# PROJECT REVIEW REPORT

<b>Project ID</b>	3115
<b>Project Name</b>	Sustainable Agricultural Practices for carbon sequestration by Organic and Natural farming groups
<b>Review Type</b>	Registration & Verification Approval
<b>Program(s)</b>	VCS Program
<b>Verification Period</b>	01 October 2017 – 31 December 2021
<b>Project Proponent</b>	Vedic Green Solutions (VGS) And Kanaka Management Services Private Limited (KMSPL)
<b>Methodology</b>	VM0017 - Adoption of Sustainable Agricultural Land Management, v1.0
<b>VVB</b>	EPIC Sustainability Services Private Limited
<b>Assessment Criteria</b>	<i>VCS Standard, v4.3</i>
<b>Date of First Issue</b>	22 February 2023

Photos showing crops grown inside the coconut plantation

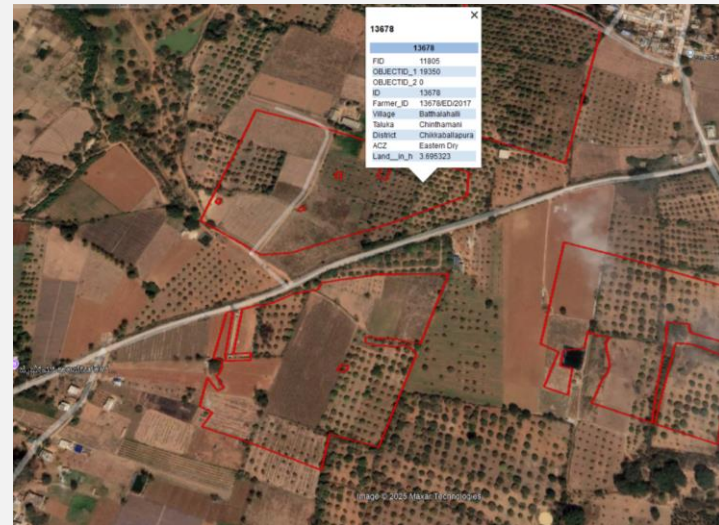
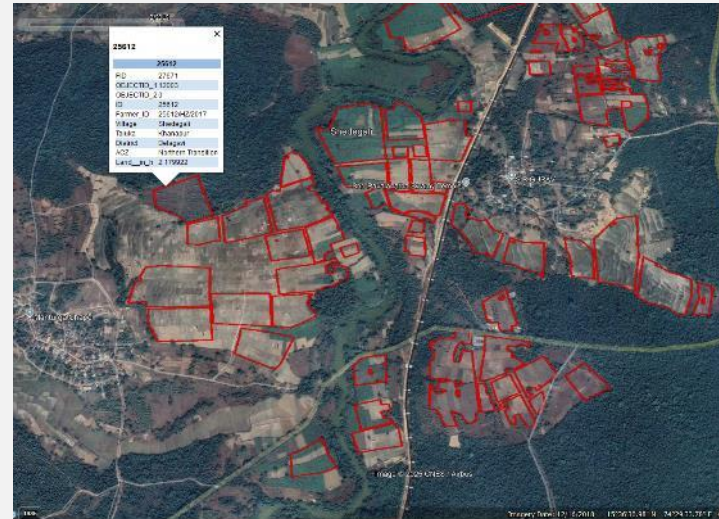
<p>VCS Standard, v4.3, Sections 3.10.1 &amp; 3.10.2</p>	<p>Verra Response</p> <p>The KML has been updated as requested to delineate the project areas. However, there are some areas appear to contain dense vegetation, which are non-project areas.</p> <p>Action Required</p> <ol style="list-style-type: none"> <li>1. The VVB must clarify if these areas with dense vegetation are part of the project area.</li> <li>2. The VVB must share a KML file that demarcates the eligible project area only.</li> </ol> <p>Program Rule(s)</p> <p>VCS Standard, v4.3, Sections 3.10.1 and 3.10.2</p> <p>Background</p> <p>Below is an example of such dense vegetation areas, The placemaker is at 13°1'44.88"N, 77°10'30.67"E.</p>	
--	---	---	--

The following placemarkers are at  $13^{\circ} 3'10.01''\text{N}$   
 $77^{\circ}12'18.44''\text{E}$  and  $13^{\circ} 3'3.41''\text{N}$   $77^{\circ}12'25.06''\text{E}$  respectively.

Based on the observations from the onsite visit and the review of KML files, the EPIC audit team has confirmed that the dense vegetation is not a part of the eligible project area. During the field visit, several examples were found within the project area where trees are present on the bunds, and crops are grown within the coconut and mango plantations. Although these plantations may appear as dense vegetation, crops are indeed being cultivated within the project area.

The EPIC audit team has collected evidence, such as photographs, to demonstrate that crops are grown inside the coconut plantations. Despite the appearance of dense vegetation in the coconut and mango plantations, the area where crops are grown is still considered part of the eligible

project area. However, any dense vegetation within the project area that does not include crop cultivation has been demarcated as ineligible. Additionally, trees on the bunds also appear as dense vegetation. Therefore, bunds with a significant number of trees have been demarcated as ineligible.
